NORTHEAST UTILITIES

Millstone Nuclear Power Station, Unit No. 3
Structural and Geotechnical
Engineering Branch
Additional Information in Response
to Confirmatory Items

Attachment I

Revised Responses to Structural Audit Items:

ACCELERATION G
 12.00
 10.00
 8.00
 6.00
 4.00
 2.00
 0.00

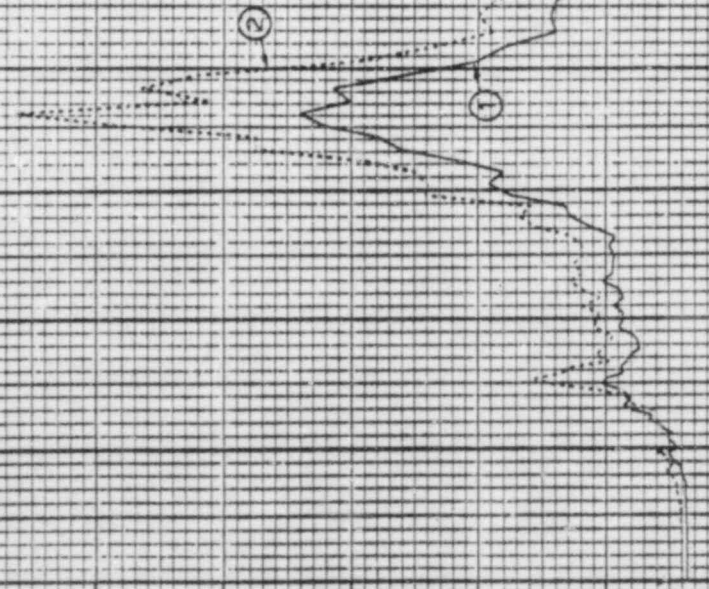
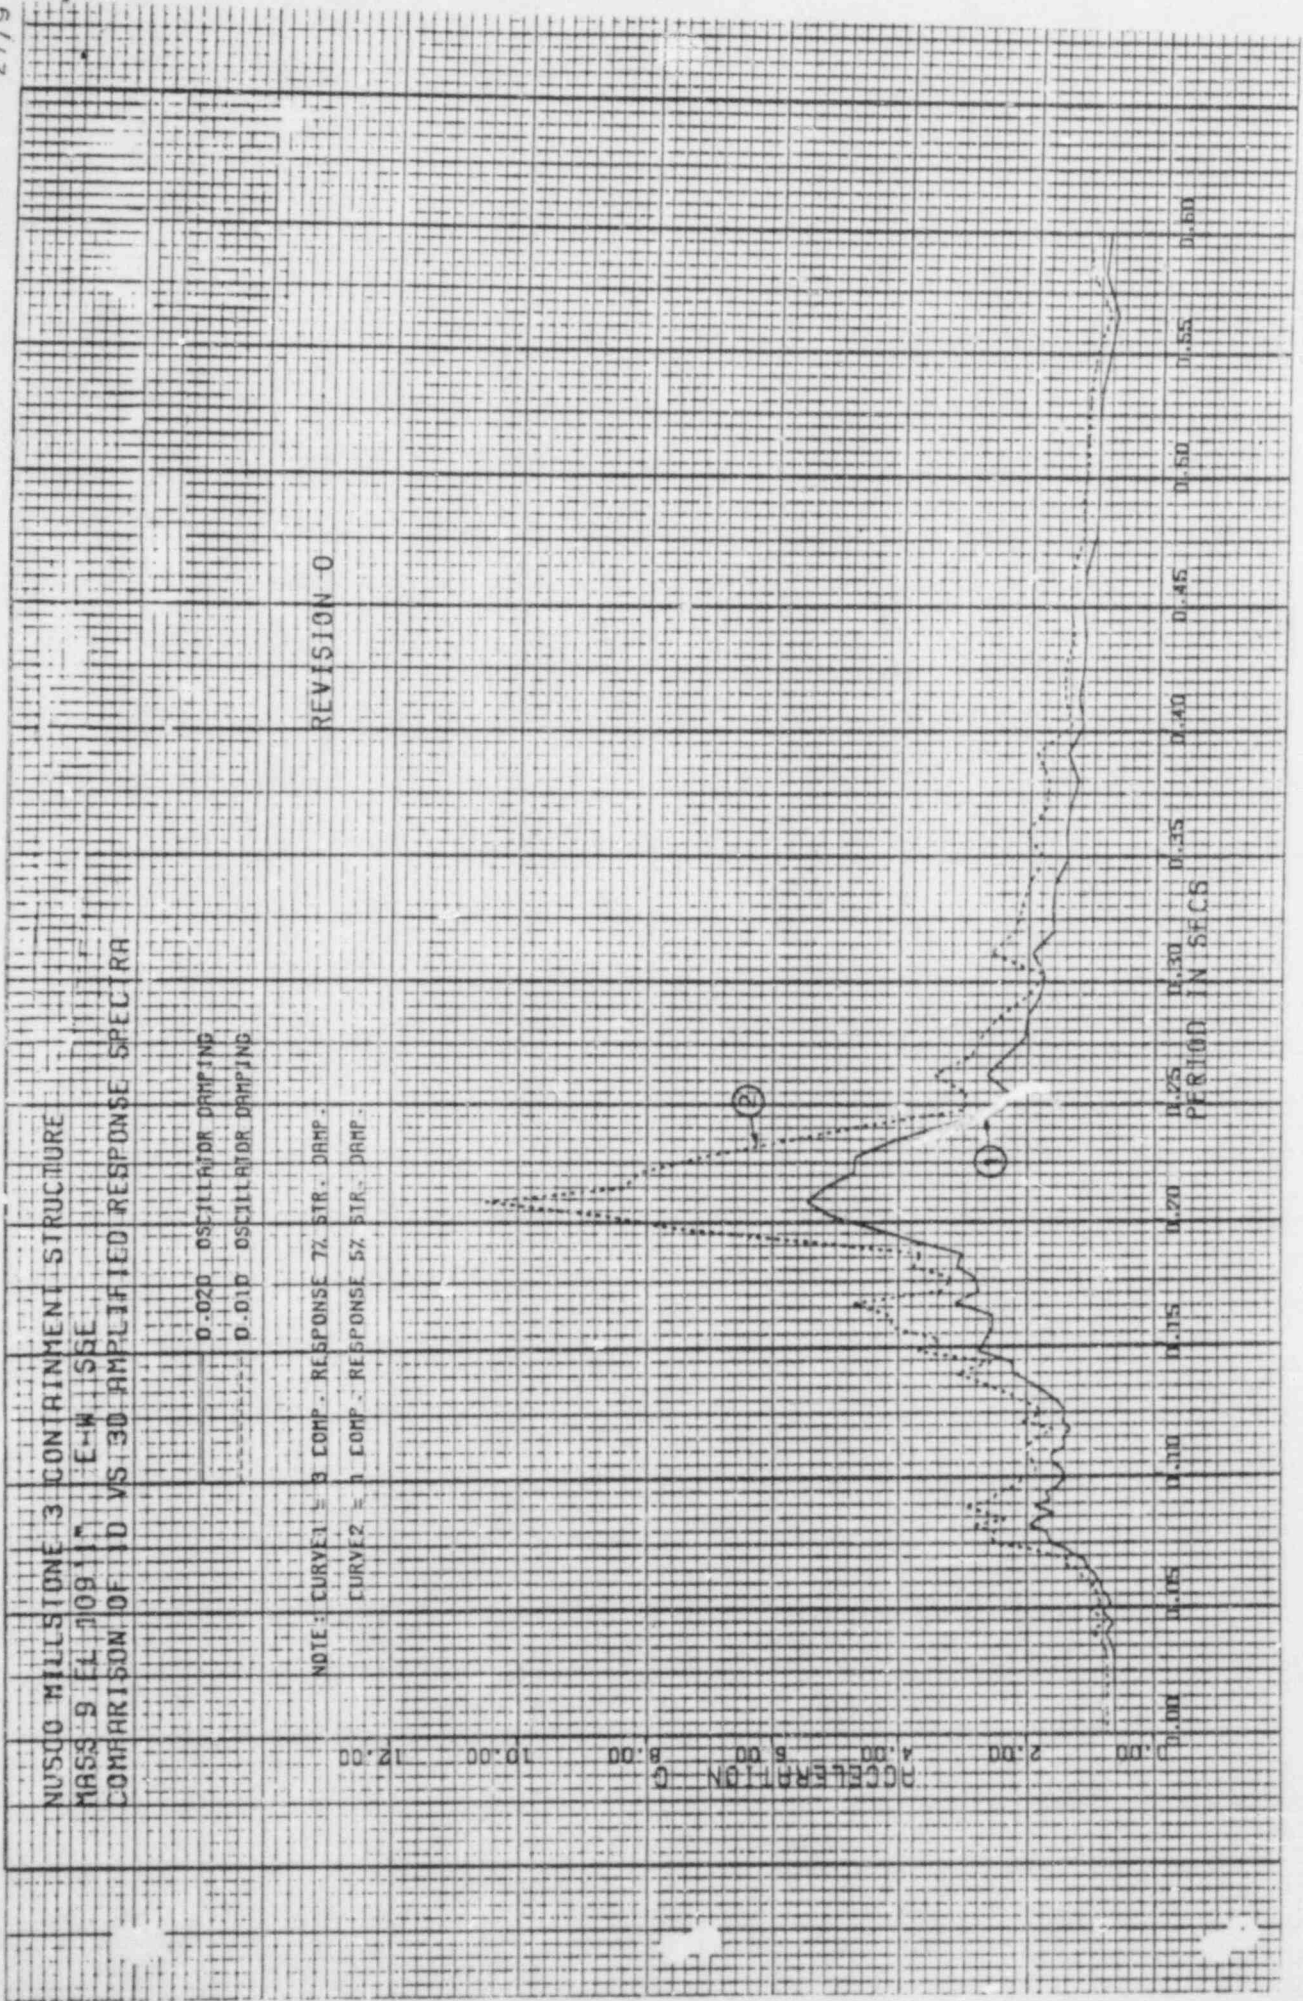
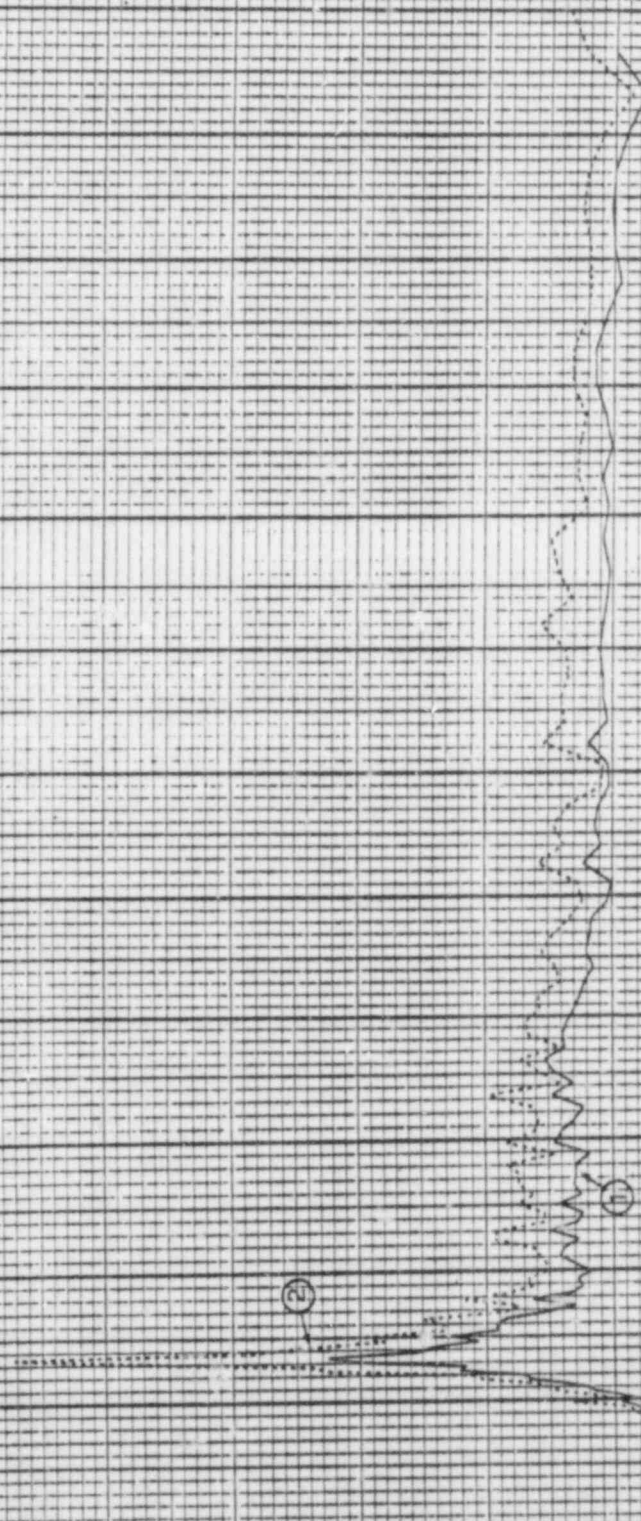
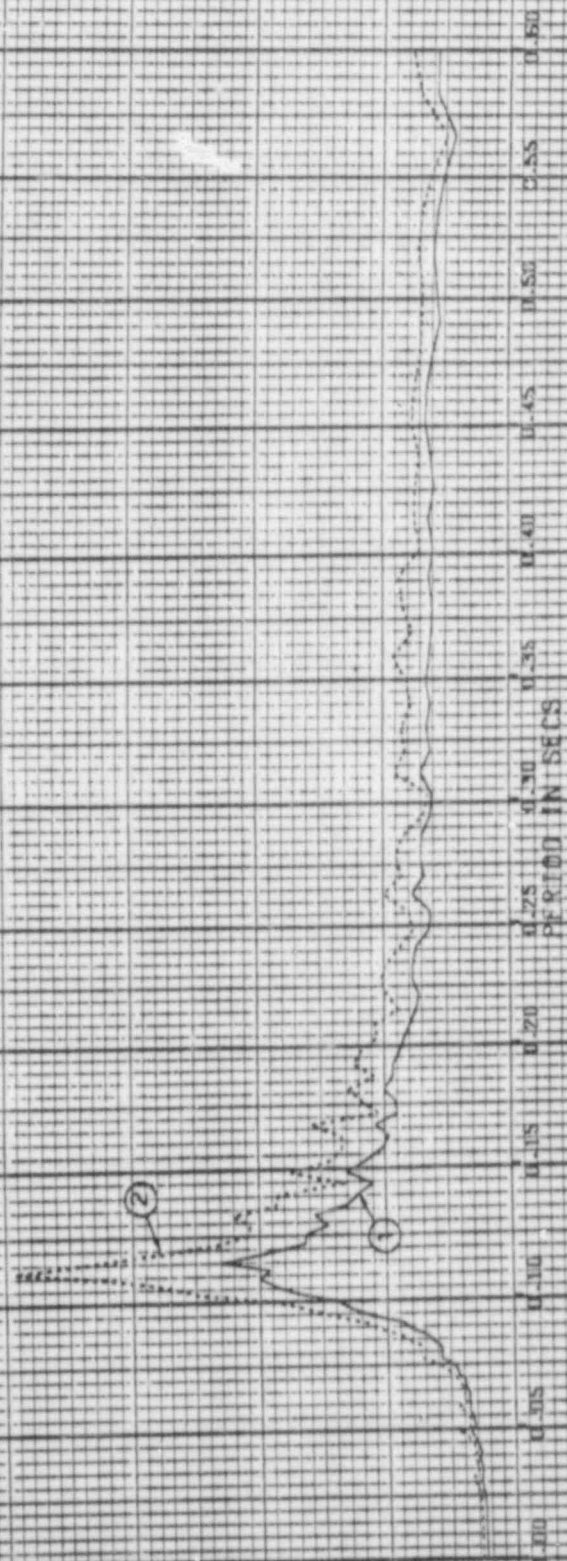
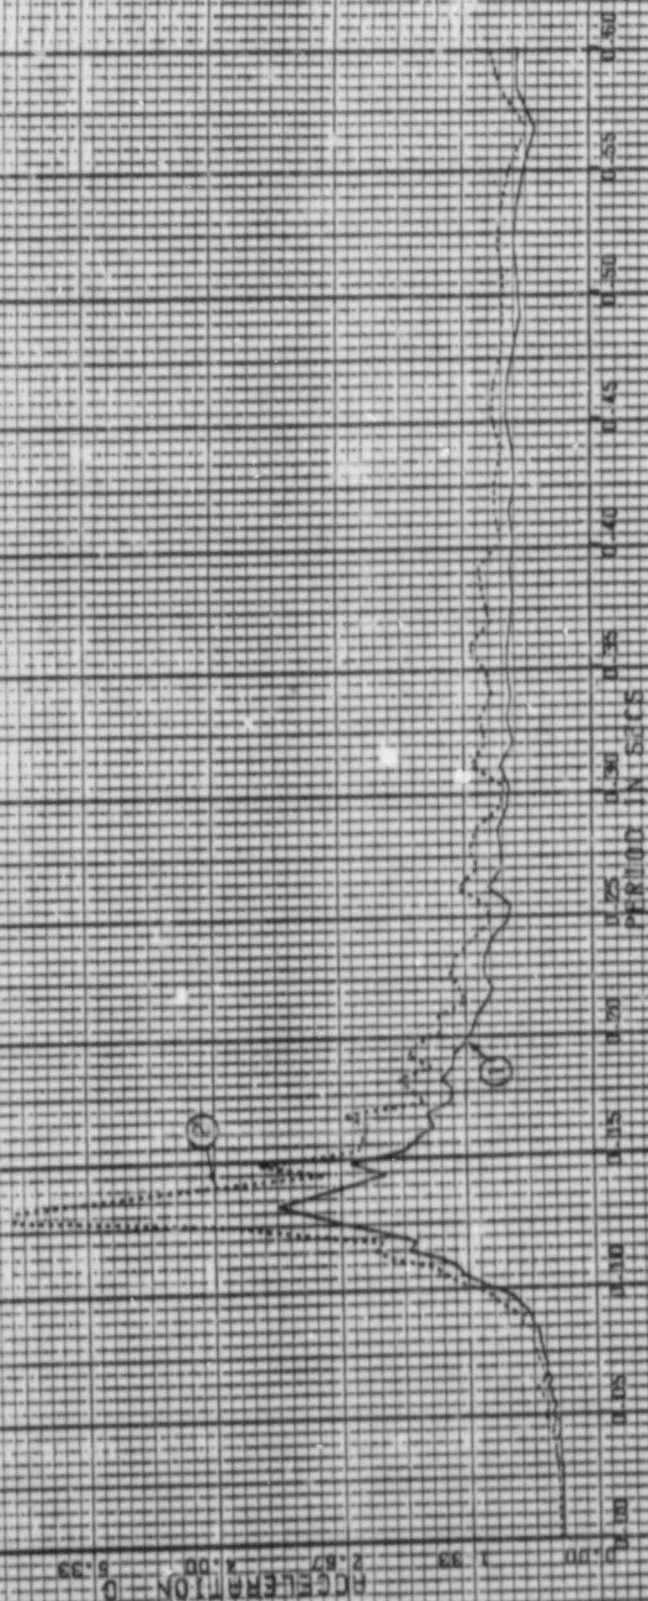
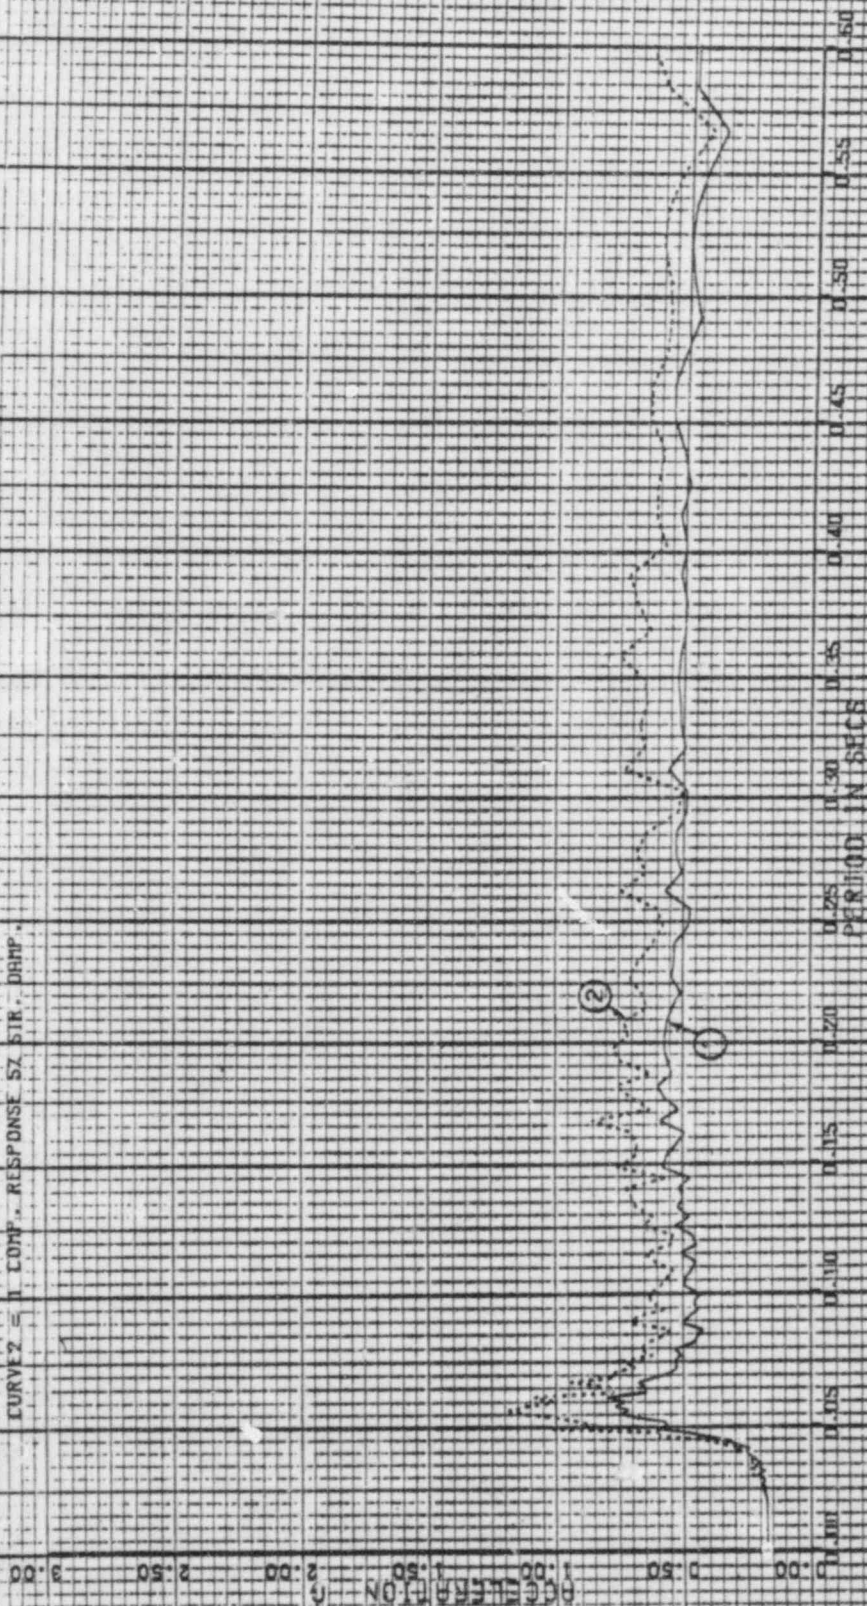
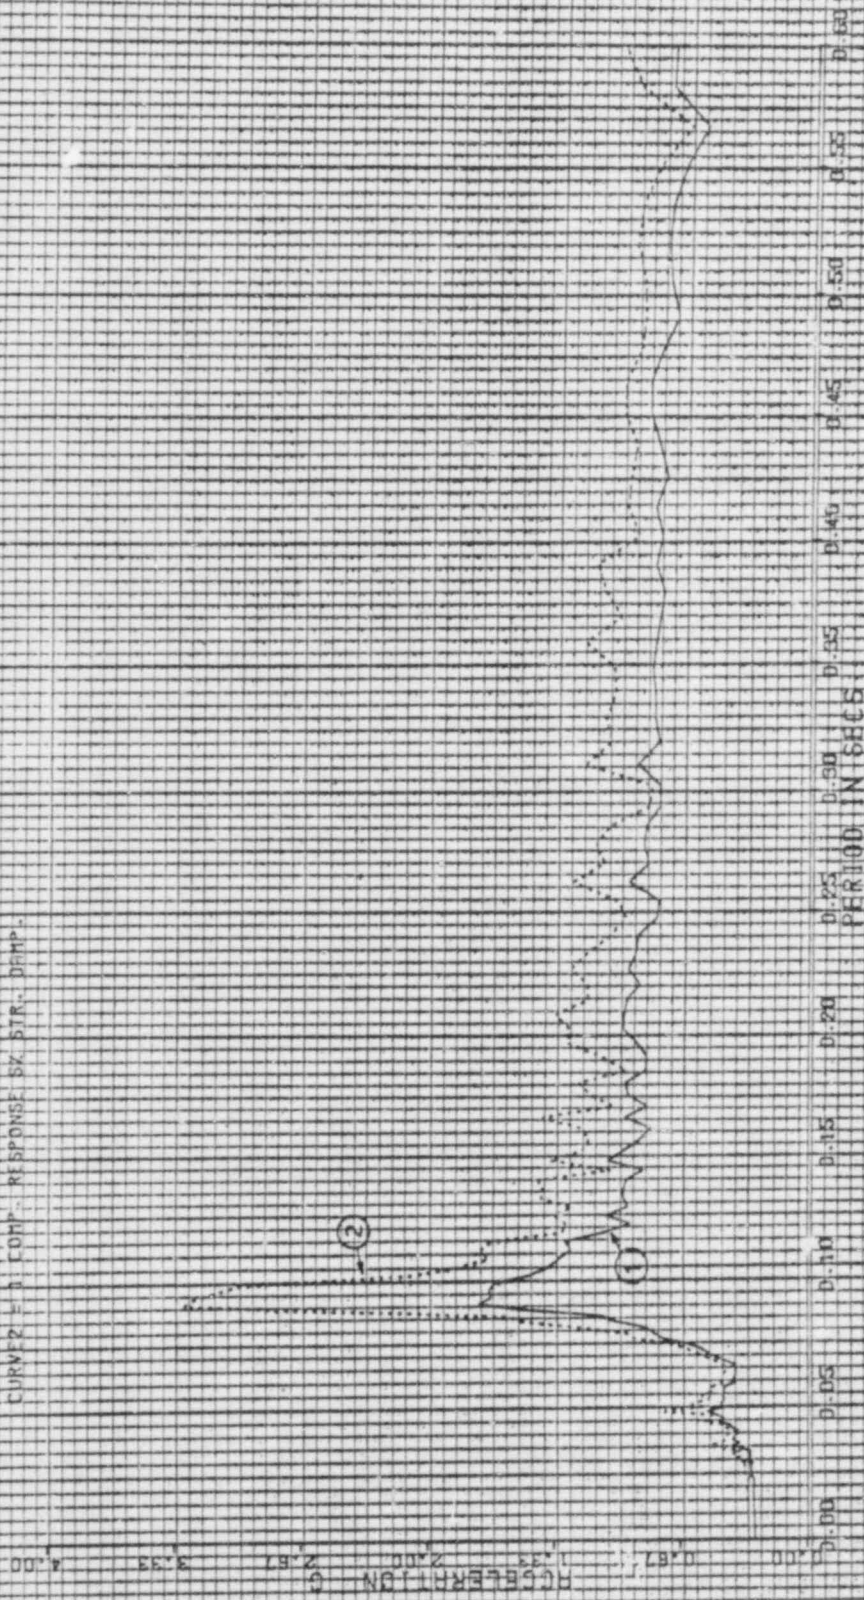
ITEM 27: Provide Justification for Generation of ARS Based Upon One
- Component of Input Motion

The method and criteria used in the generation of ARS for Millstone Unit 3 are inherently conservative. Conservative damping values are used both for structures and equipment. The conservatism in those damping values can be seen when they are compared with the recognized conservative values in Regulatory Guide 1.61. In addition, the input time history used to generate the ARS envelopes the design response spectrum as shown on Figures 3.7B-3 through 3.7B-8 of the FSAR.

To evaluate the conservatism of the one-component ARS curves, a study was conducted to provide a comparison between ARS developed for the SSE condition using:

1. One-component response with 5 percent structural damping and 1 percent oscillator damping.
2. Three-component response (SRSS of the three ARS components) with 7 percent structural damping and 2 percent oscillator damping.

To assure a study representative of all Category I buildings, the Containment Structure, Auxiliary Building, and Fuel Building were evaluated. The Auxiliary Building is representative of all Category I buildings with little coupling, and the Fuel Building is representative of buildings with a large degree of coupling. In every case, the ARS were generated for SSE condition using the three-component response and are enveloped by the response spectra that have been used in piping and equipment qualification.

The attached amplified response spectra curves used in the study are provided for the above buildings in the direction of E-W, N-S and vertical excitation are as follows:

Therefore, it is concluded that the one-component ARS curves developed for all Millstone Unit 3 Category I buildings are conservative with respect to the three-component ARS curves.
